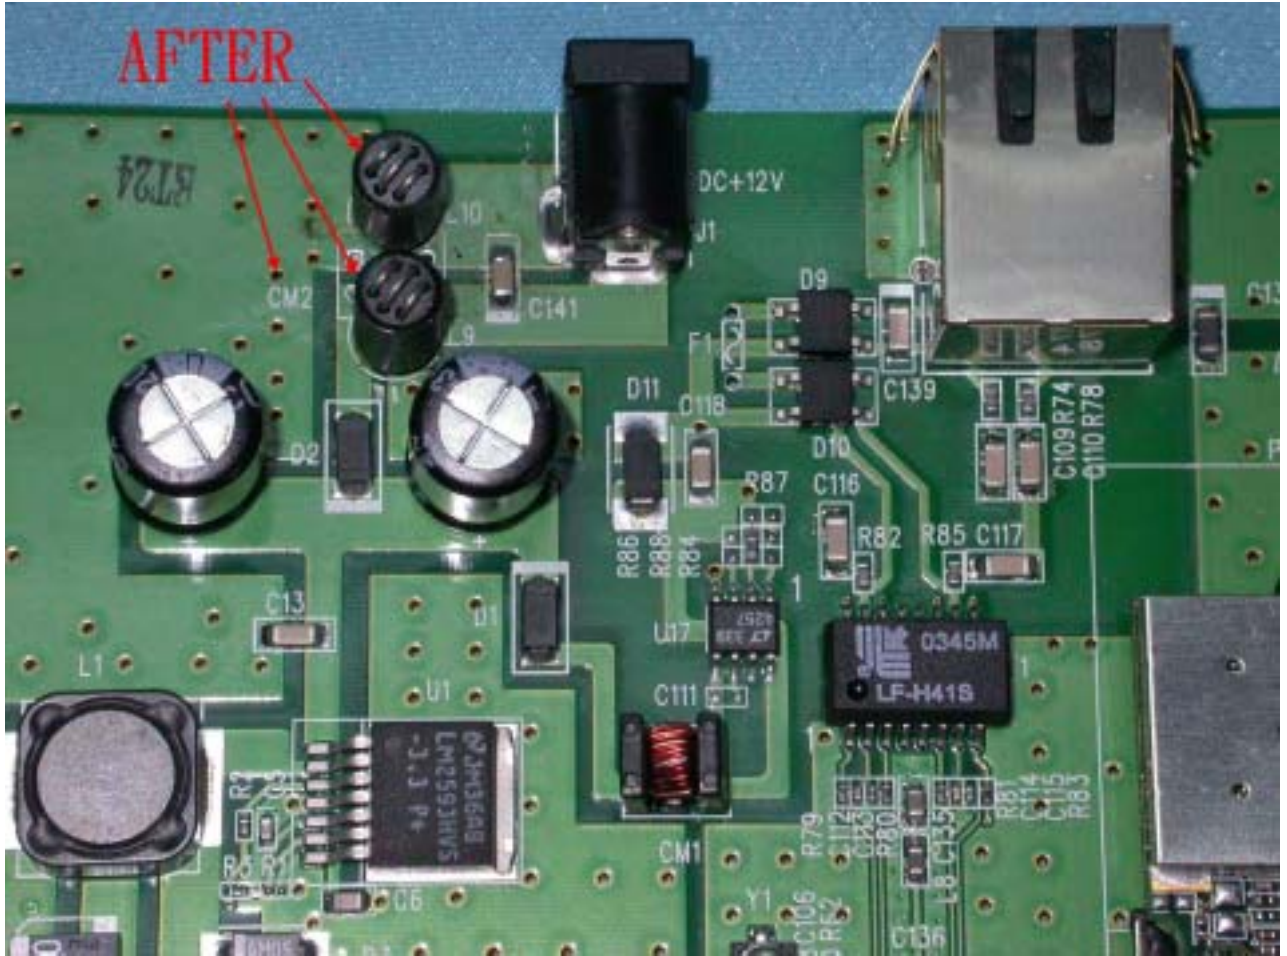
Before: There is CM2
After: Add L10.L9, but cacile CM2

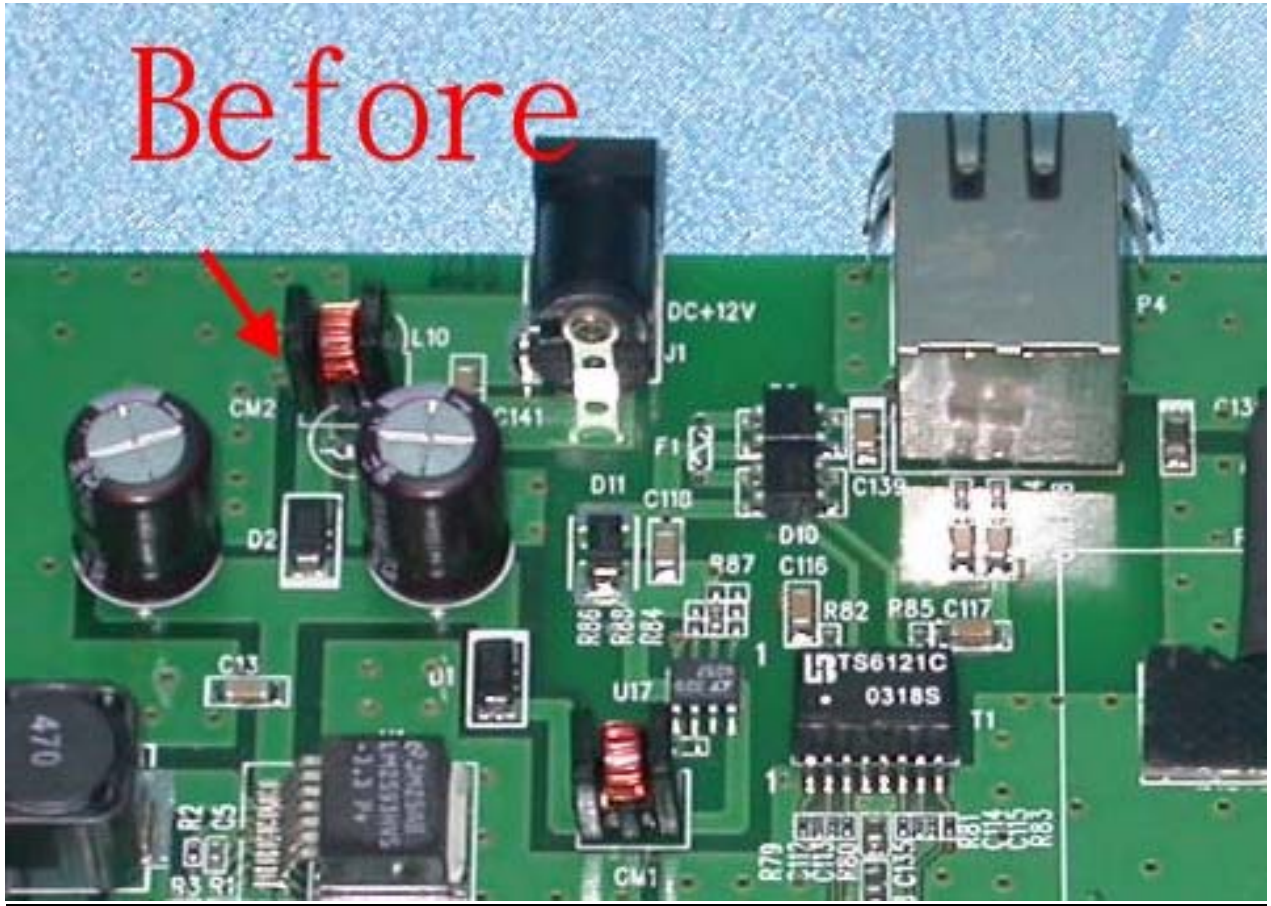
Before: C141 is 1nf
After: C141 is 4.7nf

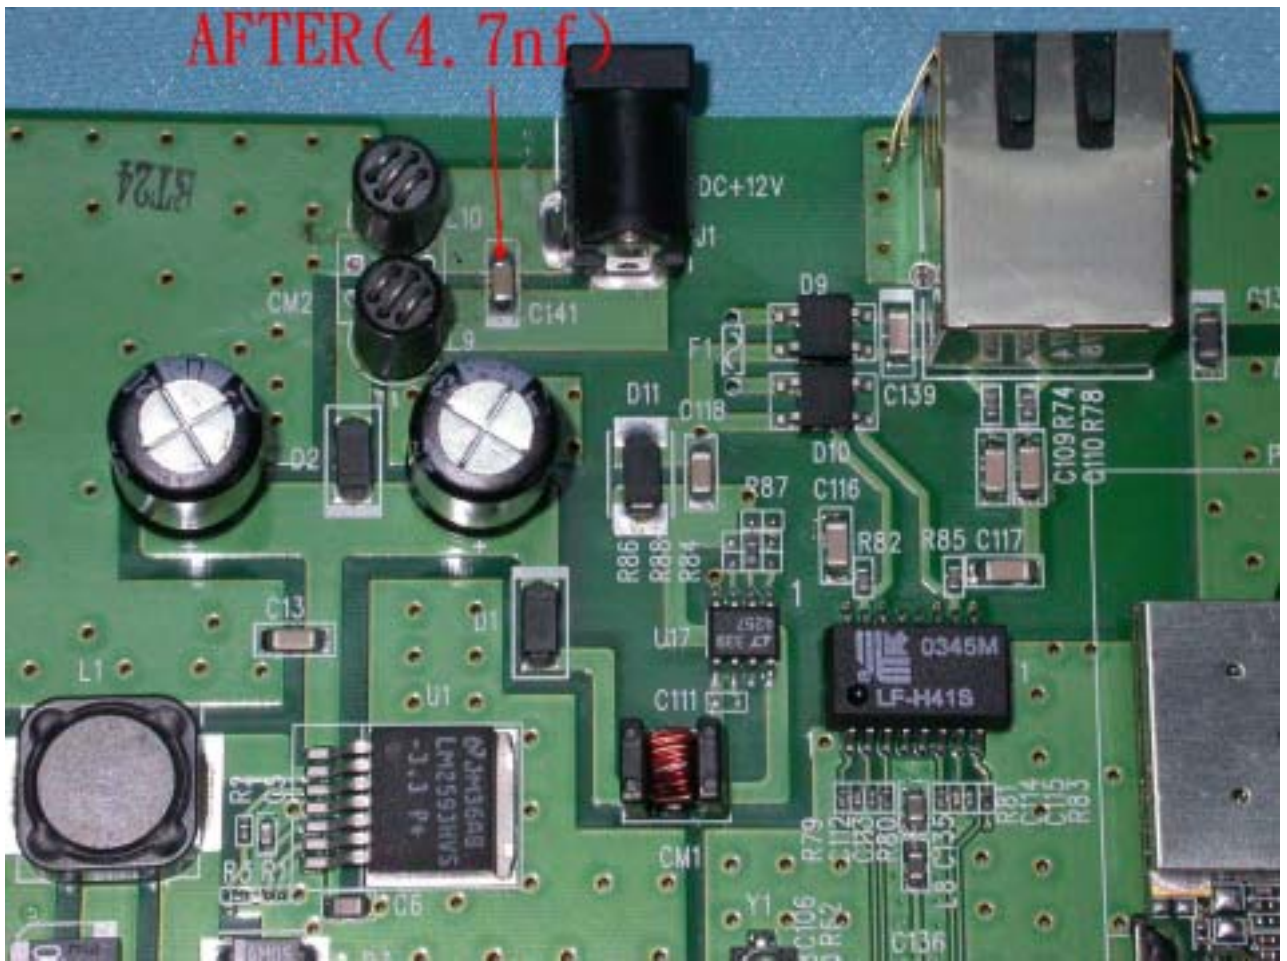
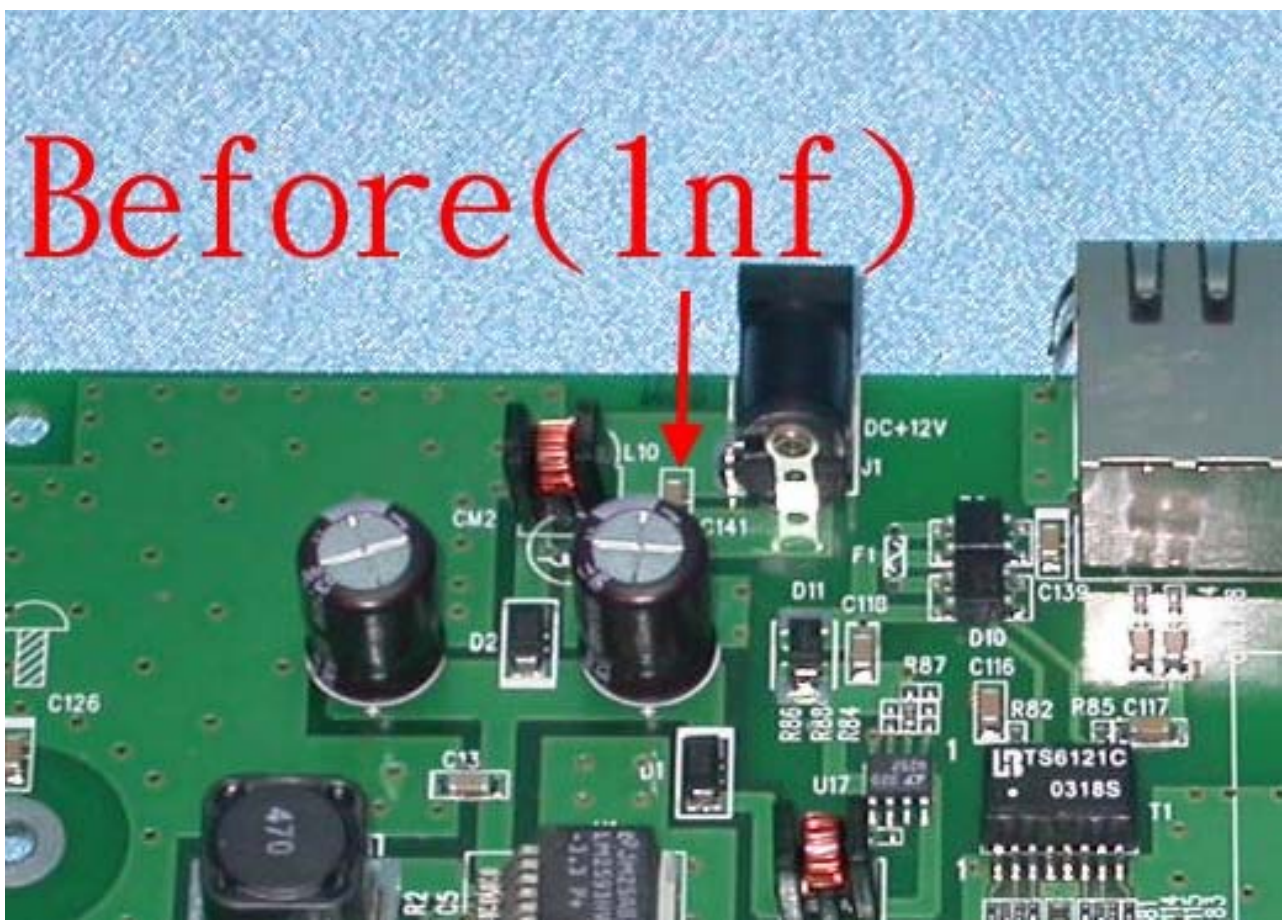
Before: There are C150, C151, C152, C153
After: There are not C150, C151, C152, C153
